Certificates of Appropriateness for 817 Williamson St

June 1, 2020

Proposal

21 Williamson Street, Madison Wisconsin RENDER

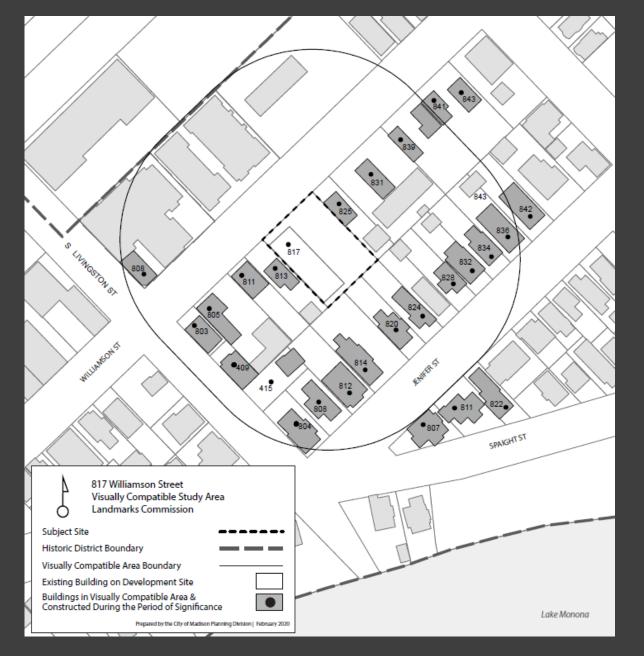
Staff believes that the standards for granting Certificates of Appropriateness for the demolition and land combination are met and should be approved as proposed. Staff believes that the Certificate of Appropriateness for the new construction could be met and recommends that the Landmarks Commission approve the proposal with the following condition:

1. Setback the southwestern bay of the street façade to approximately 8 feet to be comparable with the setback of the northeastern bay.
